Relocating the Kanmon Route No. 35 Lighted Buoy

Traffic Department, 7th Regional Coast Guard Headquarters

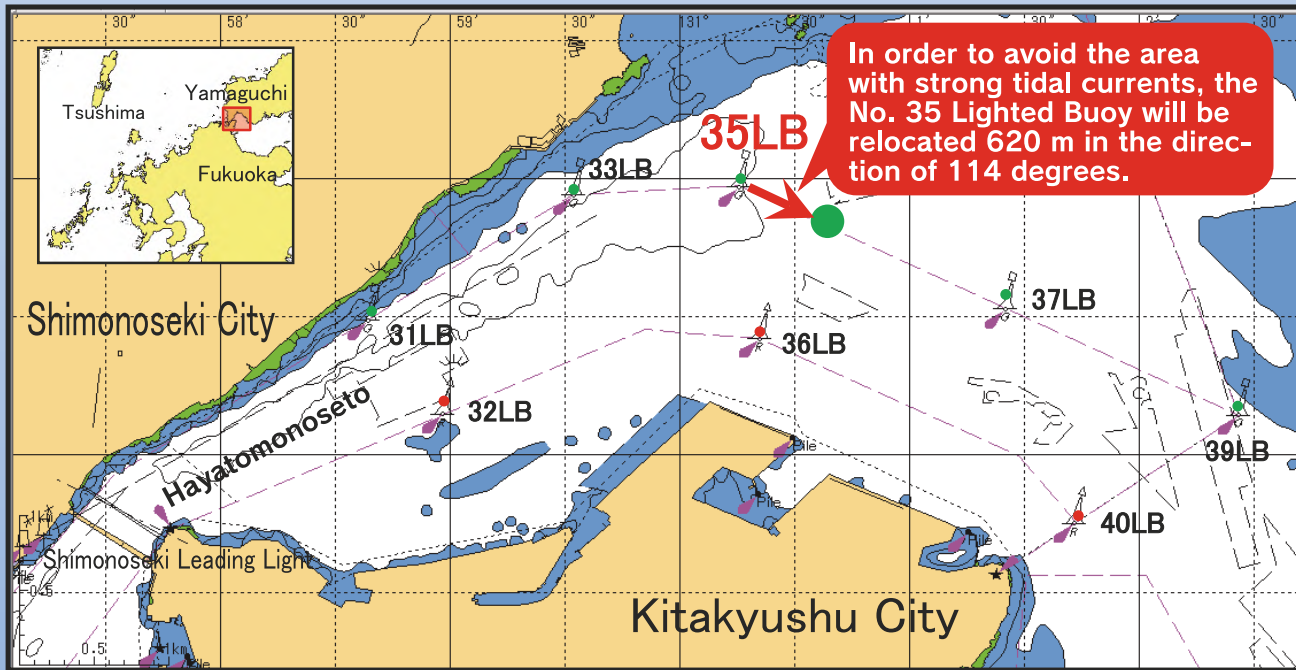
- ◆ The lighted buoy will be relocated but the normal line for passage will not change.
- ◆ Special caution is needed for vessels that use the No. 35 Lighted Buoy as a guide for veering.
(Keep to the right in the passage!)

2. New position

North latitude: 33 degrees, 58 minutes, 50 seconds
East longitude: 131 degrees, 00 minutes, 37 seconds

3. Old position

North latitude: 33 degrees, 58 minutes, 58 seconds
East longitude: 131 degrees, 00 minutes, 15 seconds

The Kanmon Route No. 35 Lighted Buoy, which has been located in an area with strong eastward tidal currents, causes vessels to converge and often hit the buoy. The lighted buoy will be relocated to a new position to prevent the buoy from being damaged or moved.

Please note that there will be no object at the old position after the lighted buoy is relocated.

The beacon number of the Kanmon Route No. 35 Lighted Buoy will remain lit at night.

"35" will be continuously lit at night (green).
